City of Alexandria, Virginia

MEMORANDUM

SUBJECT: CONCEPT REVIEW OF 1604-1614 KING STREET (KING STREET
GATEWAY), BAR CASE # 2016-0419

Figure 3: Option A, King Street elevation

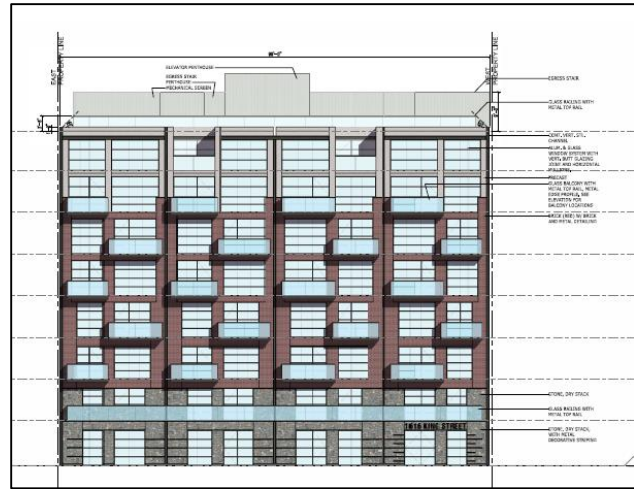
The proposed new building elevations feature two major changes: the addition of two additional cladding materials (precast concrete and stacked stone) and a new multi-light window typology. The first two stories are clad with a stacked stone “base”, topped by four floors of brick pilasters and horizontal bands, a top defined by more delicate precast concrete framing. The amount of wall cladding gets progressively lighter and thinner as the building rises, giving the impression of a heavier base and a more transparent top. The only obvious difference between Option A and Option B is the width of the alternating projecting glass balconies, which remain relatively unchanged from the previous proposal except that they are more formally organized and less random.

One of the features that staff, as well as some Board members, praised at the last meeting was the amount of glazing on the building. The latest elevations now show primarily horizontal-light windows where previously here were large glass areas with no mullions or muntins, giving the building a cleaner, lighter, and more transparent appearance. Staff understands that the applicant was encouraged by the neighbors to look at a warehouse style window. However, the horizontal mullion pattern does not seem to relate to anything on the building, except perhaps the horizontal glass balconies, and may not reflect actual conditions once doors, ventilation and structural elements are imposed on the wall system.

The applicant has indicated that they have looked to some of the more iconic Alexandria buildings for inspiration, including the early warehouse buildings near King and Union streets. While the use of gneiss fieldstone on the first two floors reflects this early building type in Alexandria, it is out of context on upper King Street, though it will be largely screened from view from King Street. Further, the use of precast concrete, while quite common on new construction and plainly visible in the King Street Metro neighborhood, only helps to draw more attention to the top of the building an area where the applicant previously stated that they wanted to visually minimize the height of the building to allow the top floors to dematerialize into the sky.

Staff supports the use of brick on the middle portion of the building to visually tie the building to its surroundings. However, the areas of brick that will be visible in perspective above the King Street townhouses is very limited, making the precast concrete and glass the most visible materials on the building. Likewise, although the projecting balconies have been somewhat regularized in the current plan, the use of precast concrete piers and the lack of balconies on the top two floors still create an irregular appearance on King Street that stands in stark contrast to nearby buildings. Staff freely acknowledges that there are no large buildings of historic merit nearby in this portion of the historic district to reference - -the nearest being, perhaps, the Art Deco styled Coca Cola building at 1500 King. In addition, BAR staff has much less concern about the Dechantal Street (south) elevation because it is effectively an alley that is used very little by the general public. The east and west sides of the building will be minimally if at all

Staff recommends that the Board *defer* the concept design for the proposed development so that the applicant can continue to refine the architectural character of the multi-story residential building.
